# AGENDA

**May 19, 2011 Standards Committee Meeting**

RE: Agenda for the May 19, 2011 Standards Committee Meeting

805-SGCF-01 CONTROLLER CABINET FOUNDATION TYPE P-1

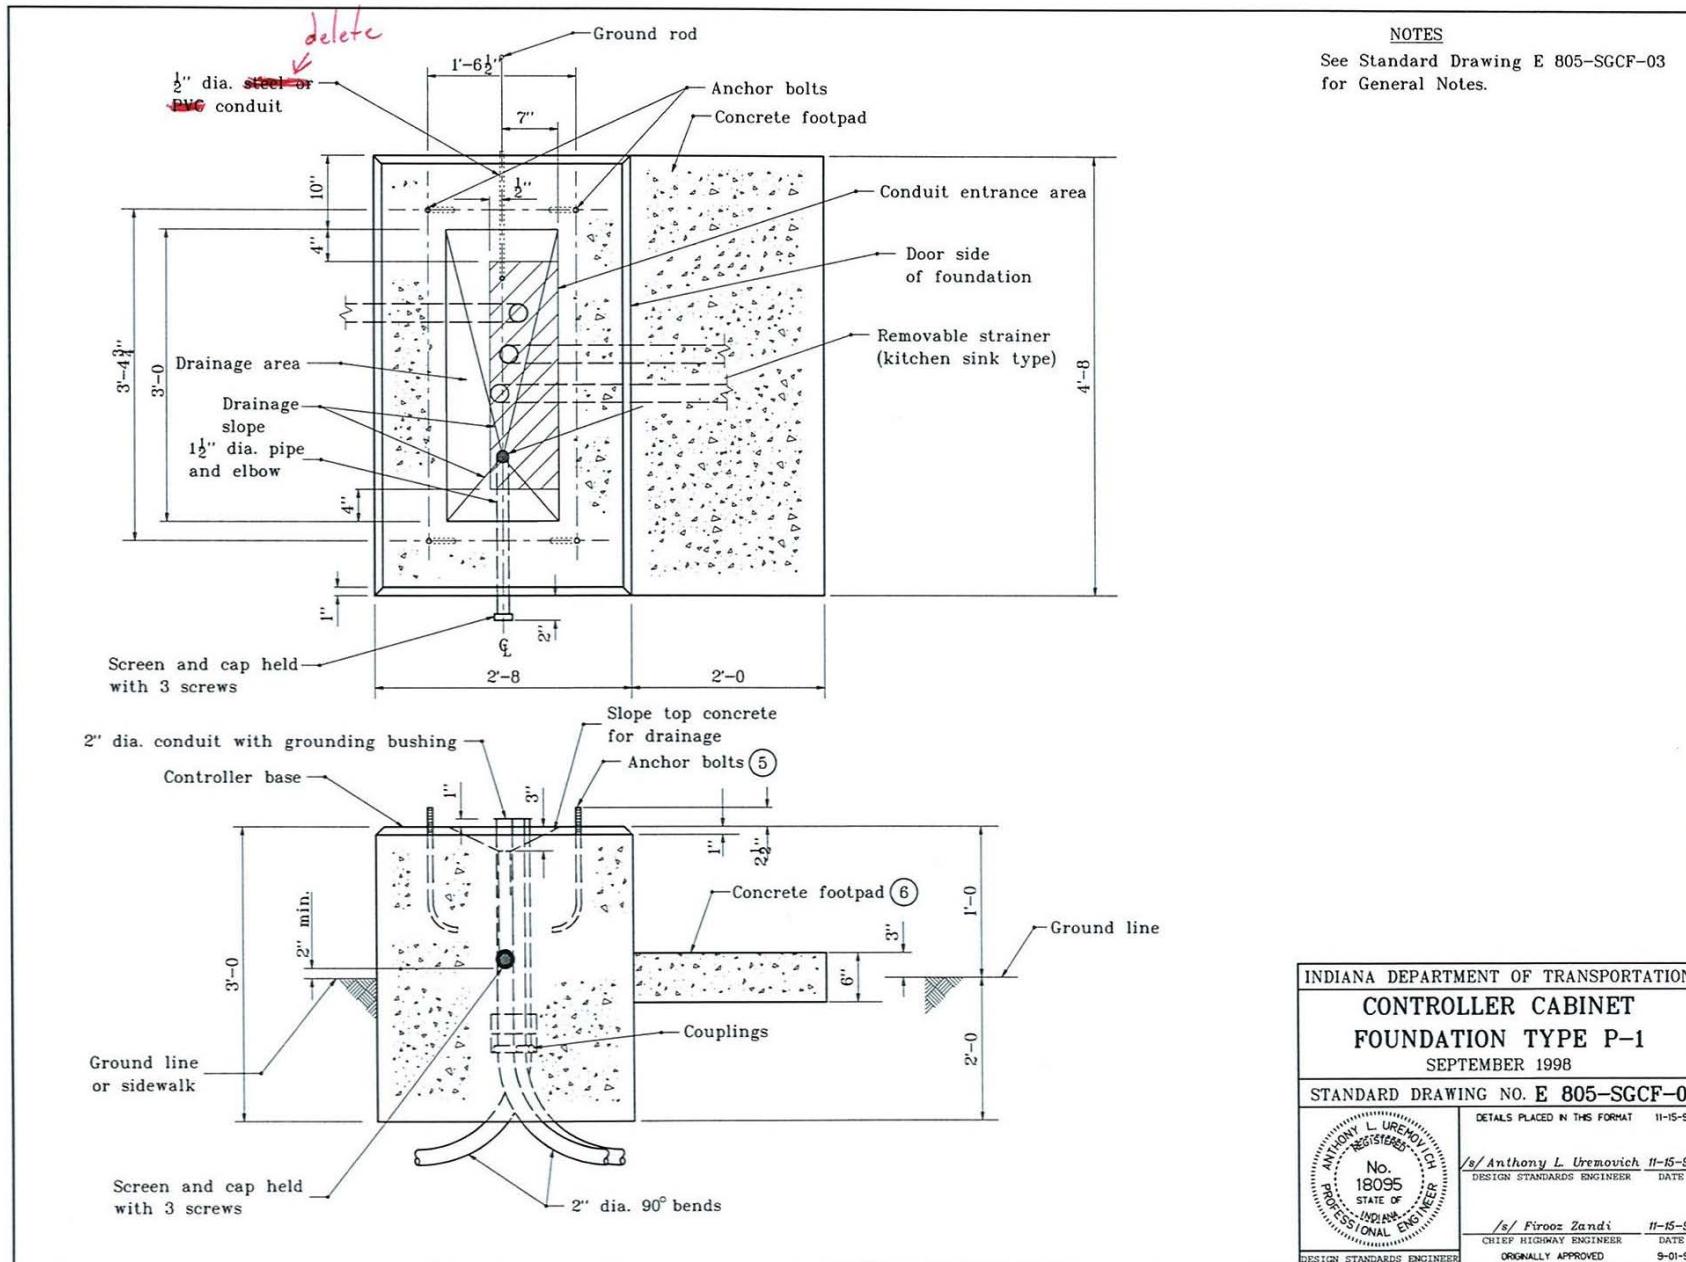
PROBLEM(S) ENCOUNTERED: Steel conduit for traffic signal cables is used extensively at INDOT's signalized intersections but the industry has developed cheaper alternatives, namely fiberglass and PVC to replace steel conduit in many situations.

PROPOSED SOLUTION: Amend recurring special provision 805-T-169 and 922-T-168 so that the conduit pay item covers steel, PVC, and fiberglass conduit and provide instructions on when PVC or fiberglass conduit may be used on a project.

706-BRPP-01 RAILING, PF-1

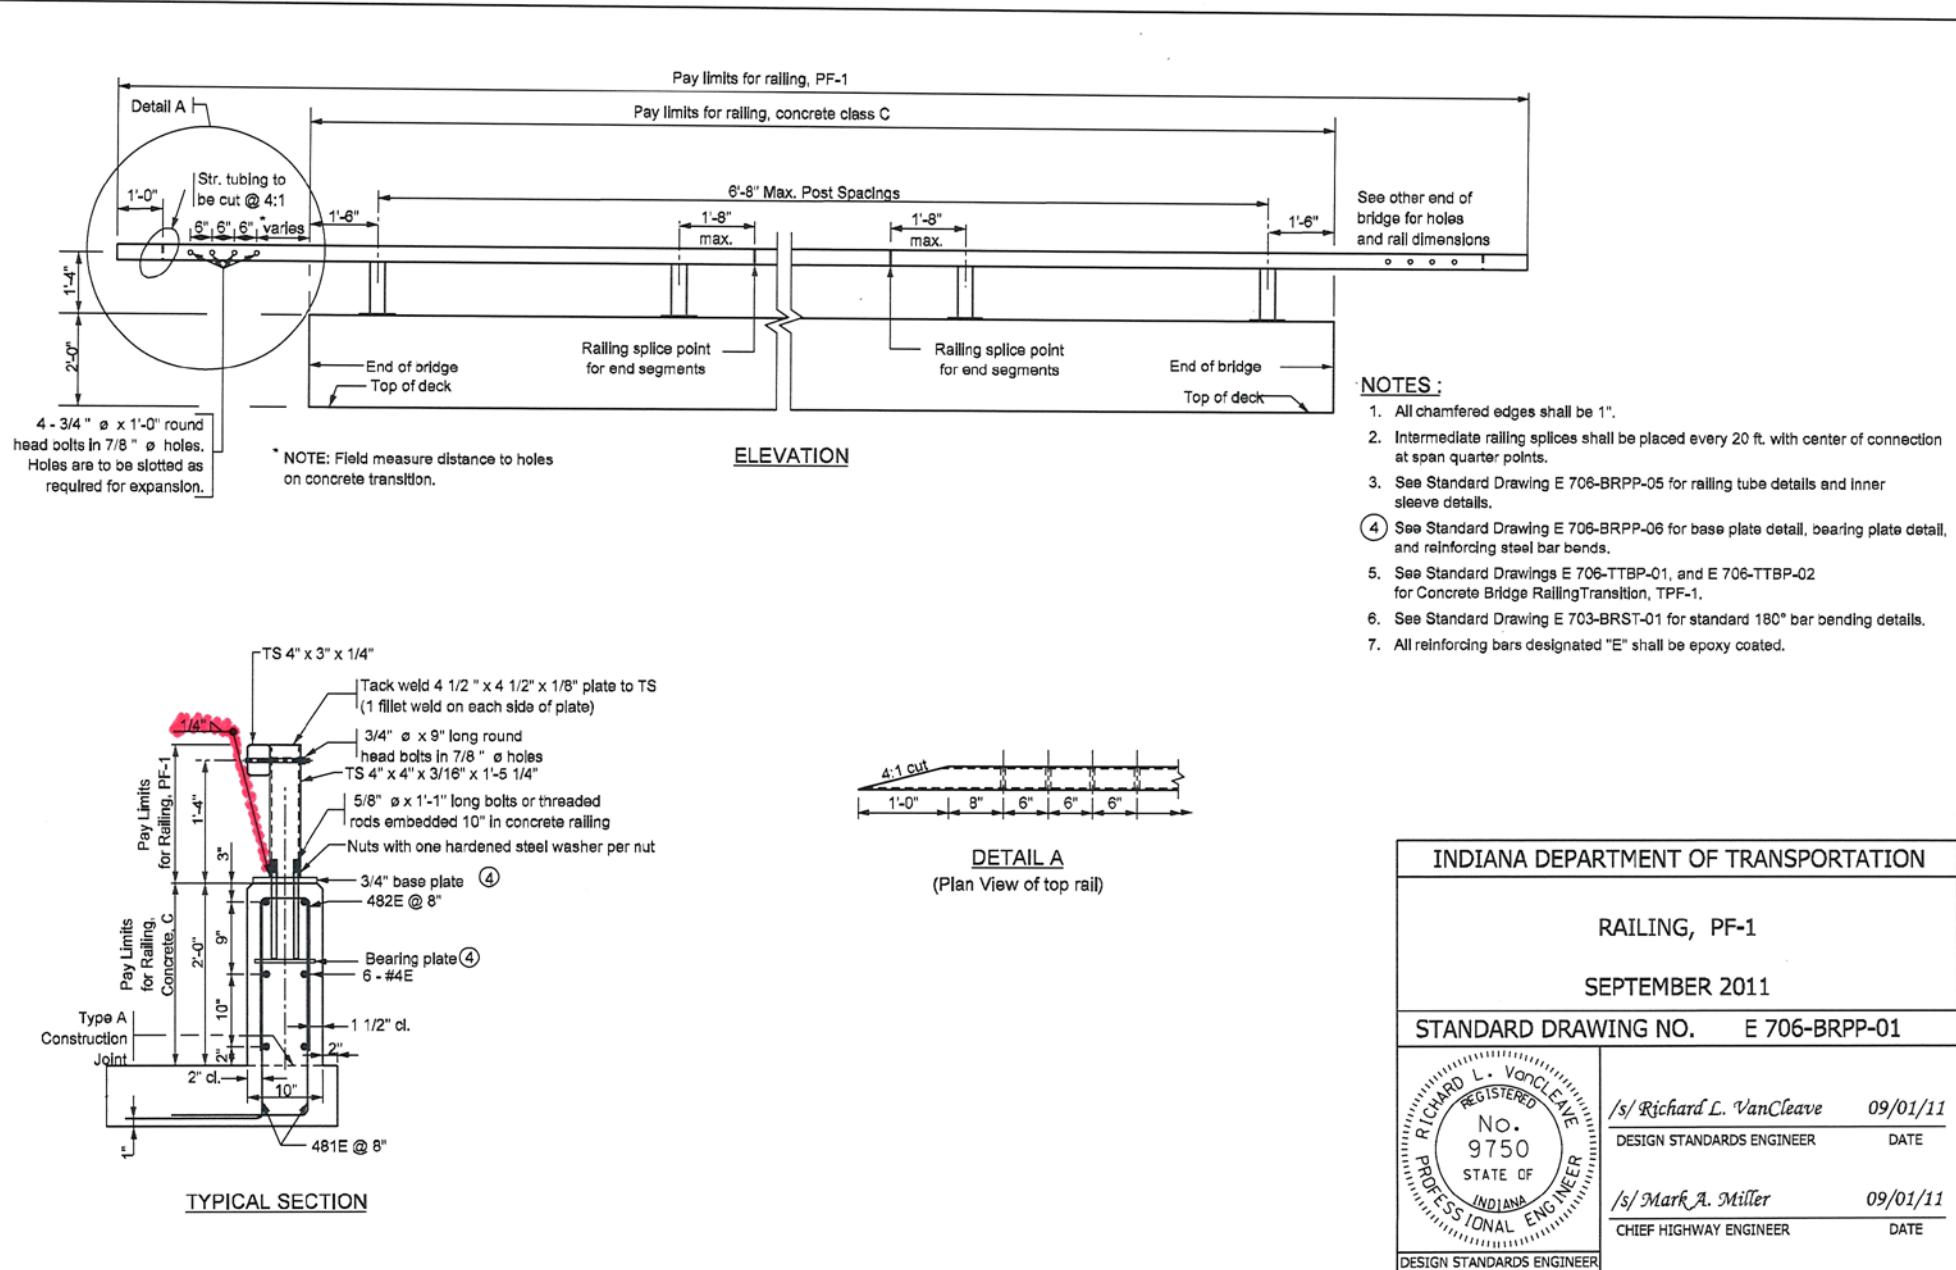
PROPOSED SOLUTION: Show the welding requirements where necessary.
